**CITY PLAN COMMISSION****THURSDAY, JUNE 25, 2026****FILE NUMBER:** PLAT-26-000152**SENIOR PLANNER:** Sharmila Shrestha**LOCATION:** Shady Trail, south of Royal Lane**DATE FILED:** May 29, 2026**ZONING:** PD 498**PD LINK:** <https://dallascityhall.com/departments/city-attorney/pages/articles-data.aspx?pd=498>**CITY COUNCIL DISTRICT:** 6**SIZE OF REQUEST:** 2.1665-acres**APPLICANT/OWNER:** Mohamed Amin Dossani

**REQUEST:** An application to replat a 2.1665-acre tract of land containing part of Lot 3 and all of Lot 4 in City Block M/6524 to create one lot on property located on Shady Trail, south of Royal Lane.

**PRELIMINARY PLAT**  
 PLAT-26-000152  
 AMIN ADDITION  
 ALL OF LOT 15 AND A PORTION OF LOT 14,  
 FIRST TEXAS BANK SUBDIVISION, PHASE II  
 WILLIAMS MOOREWORTH SURVEY, ABSTRACT NO. 942  
 CITY OF DALLAS, DALLAS COUNTY, TEXAS

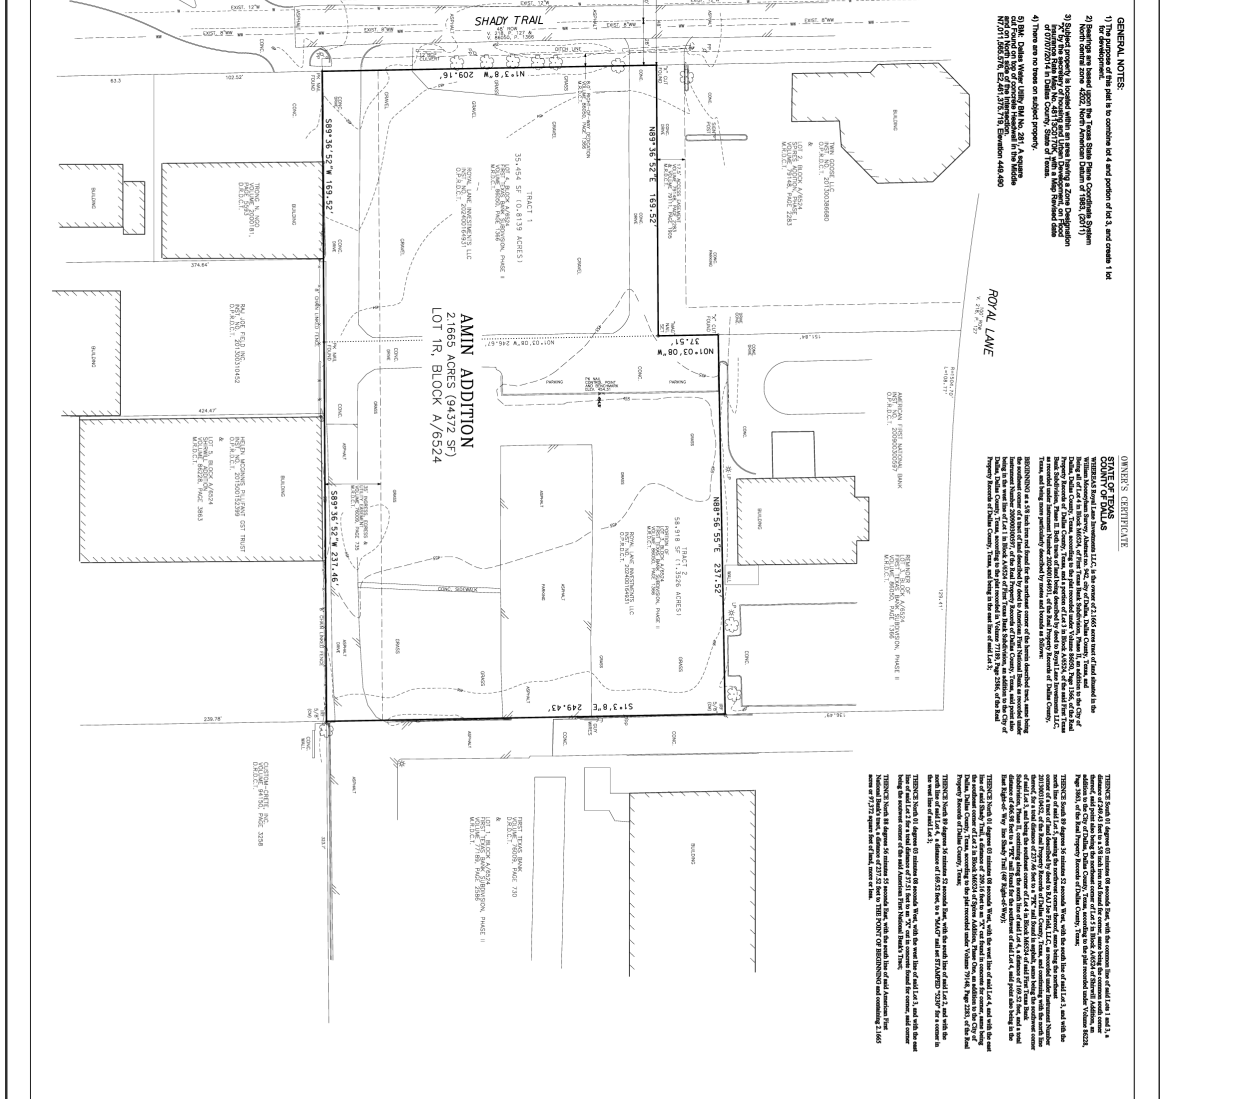
7. On the final plat, include two boundary corners tagged with these coordinates: "Texas State Plane Coordinate System, North Central Zone, North American Datum of 1983 on Grid Coordinate values, No Scale and no Projection."

8. On the final plat, monument all set corners per the Monumentation Ordinance. Prior to submitting the final plat for the Chairman's signature, the monuments

17. Prior to final plat, submit a completed final plat checklist and all supporting documents.
18. Show abstract line location.

19. Additional design information is required for assessment. Site plan must be submitted showing proposed development, building finished floor elevation, development, existing mains – including downstream manhole, and proposed water and wastewater service locations. Submit water/wastewater engineering plans to 320 E. Jefferson Blvd., Room 200, Attention: Water and Wastewater Engineering.
20. Water main improvement is required by Private Development Contract. Submit water/wastewater engineering plans to 320 E. Jefferson Blvd., Room 200, Attention: Water and Wastewater Engineering.

21. Existing and any proposed Water and Wastewater Easements must be shown and/or increased to conform to current design standards. Notice: Minimum DWU easement size 20' for one utility and 25' for both water and sewer. Larger diameter or deeper mains may require additional width.

22. On the final plat, change "Harry Hines" to "Harry Hines Boulevard (FKA U.S. Highway No. 77)."
23. On the final plat, change "Shady Trail" to "Shady Trail (FKA Letot Lane)."
24. On the final plat, identify the property as Lot 4A in City Block A/6524.
